ASOS MODIFICATION NOTE 52 (for Electronics Technicians)

SUBJECT : Class I Automated Surface Observing System (ASOS) Solid State Time Delay Relay (SSTDR) for the Data Collection Package (DCP)

PURPOSE : The addition of an SSTDR is to ensure a proper reset of the Class I DCP ASOS system (*systems without an Uninterruptible Power Supply (UPS)*) during an interruption of power.

Figure 2 DCP SSTDR Mounting Location within DCP Cabinet

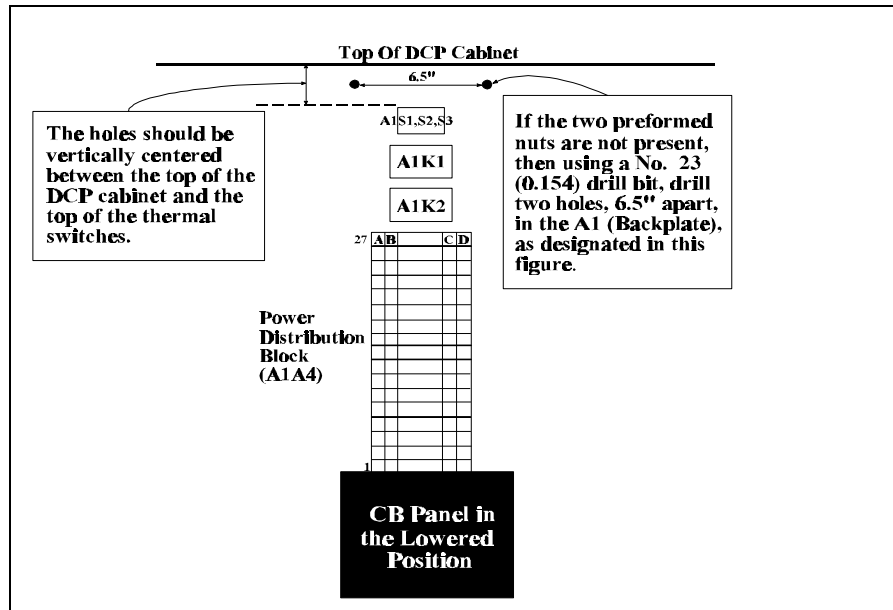
4. Above the thermal switches (2A1S1, S2, S3), there may be two preformed nuts in the A1 backplate. If so, proceed to step 6, if not, proceed with the next step (Refer to figure 2).

5. Using a drill bit (5/32-inch) and the Din Rail as a template, drill two holes in the A1 backplate, as designated in figure 2, to install the 2A1A9 assembly.
6. Install the DCP SSTDR assembly, 2A1A9, behind the circuit breaker rack and above the Power Distribution Block (PDB), 2A1A4, as shown in figure 2. *If the preformed nuts are installed, use the two machine screws, flat washers, and lock washers. If the holes needed to be drilled, use the two self-tapping screws, flat washers, and lock washers.*
7. On the DCP PDB, 2A1A4, remove and cap wires (GRY 14) 2A1A4-1B and 2A1A4-12A.

Figure 3 General Wiring Diagram on FMK Din Rail

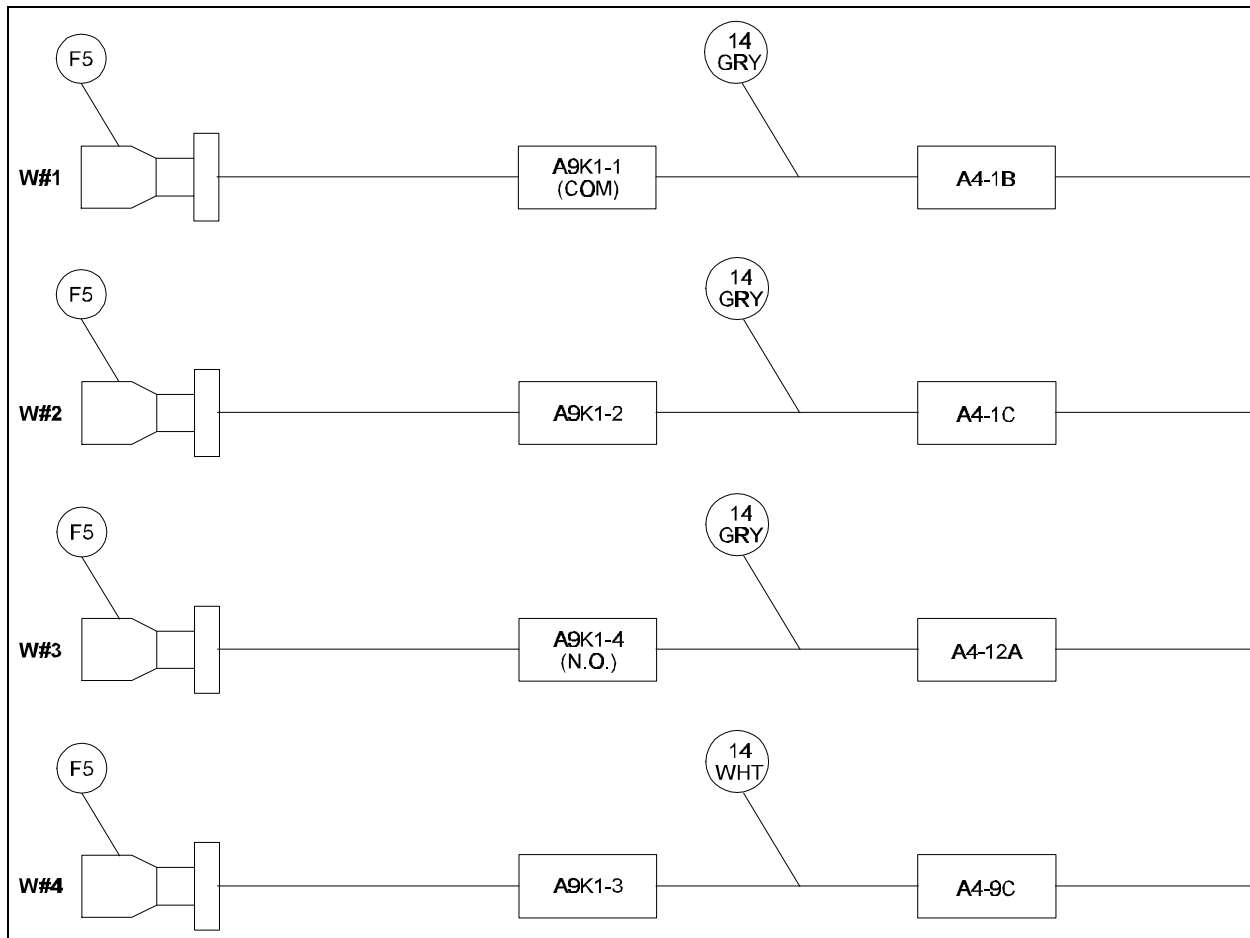
8. Connect the following wires between the PDB, 2A1A4, and DCP SSTDR:
(Use figure 3 as a reference).

- Connect wire A1A4-1B/A1A9K1-1 to A4-1B.
- Connect wire A1A4-1C/A1A9K1-2 to A4-1C.
- Connect wire A1A4-9C/A1A9K1-3 to A4-9C.
- Connect wire A1A4-12A/A1A9K1-4 to A4-12A.
